ATTACHMENT B
NRC STAFF RESPONSES TO THE LICENSING BOARD'S
INITIAL QUESTIONS REGARDING THE FEIS

NRC STAFF RESPONSES TO THE LICENSING BOARD'S INITIAL QUESTIONS REGARDING THE FEIS

Figure 1
Worst-Case 24-hour Total PM₁₀ Concentrations (Background plus *Highest* Concentrations from Emissions Related to the Proposed Action) during (a) Land Clearing Phase and (b) Building Construction Phase

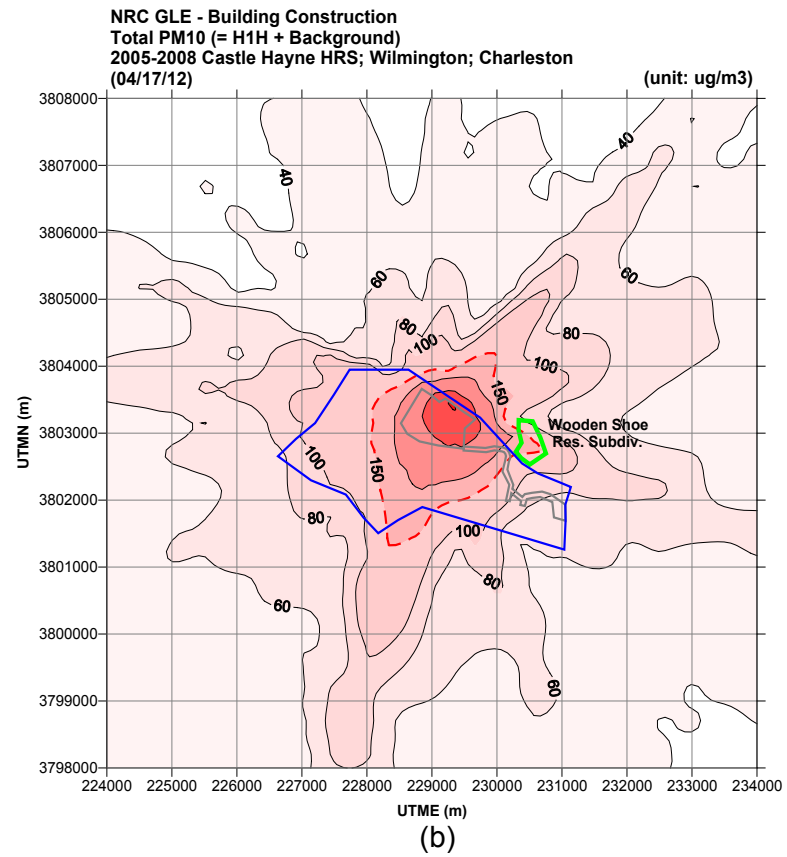
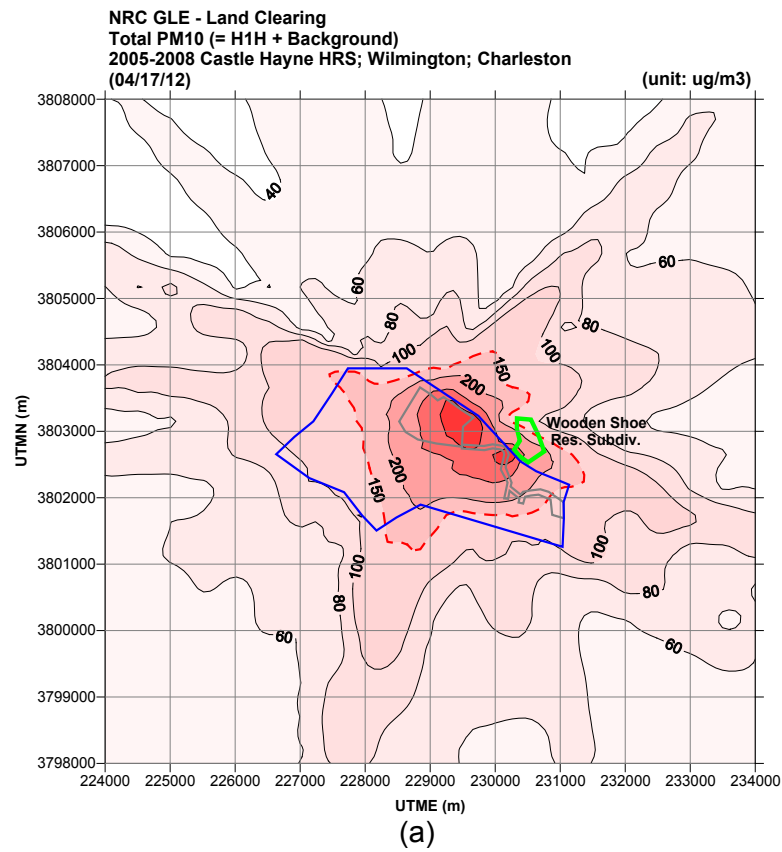
FEIS Question No. 22: *Twenty-four hour concentrations of particulate matter are predicted to exceed air quality standards during preconstruction and construction phases. How widespread will this decrease in air quality be? What effects are expected on the residents of the Wooden Shoe residential subdivision? (EIS 4-13)*

Response No. 22 (Y.-S. Chang): The worst-case concentrations of 24-hour total (background plus contribution from the proposed GLE Facility) particulate matter (PM), including coarse particulate matter (PM₁₀) and fine particles (PM_{2.5}), associated with land clearing activities are predicted to exceed the respective National Ambient Air Quality Standards (NAAQS) at the proximate northern boundary of the Wilmington Site near the proposed GLE Facility (less than 50 meters [164 feet] from the boundary). Comparably high PM concentrations are also predicted at the northern site boundary near the Wooden Shoe residential subdivision, close to which the North access road would be located (about 25 meters [82 feet] from the boundary). The high PM concentrations at the Wooden Shoe residential subdivision would result primarily from fugitive dust emissions during vehicle traffic on unpaved roads during the land clearing phase. On average, up to 2 and 3 days per year are predicted to have NAAQS exceedances for PM₁₀ and PM_{2.5}, respectively, at residences adjacent to the North access road in the Wooden Shoe subdivision during the land clearing phase. As shown in Figure 1a (following this response), worst-case 24-hour total PM₁₀ concentrations (background plus *highest* concentrations from emissions related to the proposed action) over the NAAQS level during land clearing could reach approximately 0.6 mile (1.0 kilometer) from the Wilmington Site boundary near the proposed GLE Facility and about 0.3 mile (0.5 kilometer) from the northern site boundary near the Wooden Shoe residential subdivision. The concentration contours in Figure 1 represent the highest concentrations at each receptor over the modeling period, not an instantaneous 24-hour average for any single day. The worst-case total 24-hour concentration contours for PM_{2.5} are wider than for PM₁₀, but distances to the 24-hour NAAQS level are similar to that for PM₁₀.

During building construction, predicted 24-hour total PM concentrations would exceed their respective NAAQS beyond the site boundary, mostly to the north of the proposed GLE Facility. However, an average of less than one exceedance per year is anticipated to occur in the Wooden Shoe residential subdivision because the subdivision is about 0.8 mile (1.3 kilometer) east of the proposed GLE Facility site, just off the prevailing southwesterly winds, and because the North access road would be paved at the conclusion of the land clearing phase. As shown in Figure 1b (following this response), the worst-case 24-hour total concentration contours for PM₁₀ during building construction are smaller than during land clearing, but the distances to the NAAQS level are similar. The same is true for PM_{2.5} during land clearing and building construction.
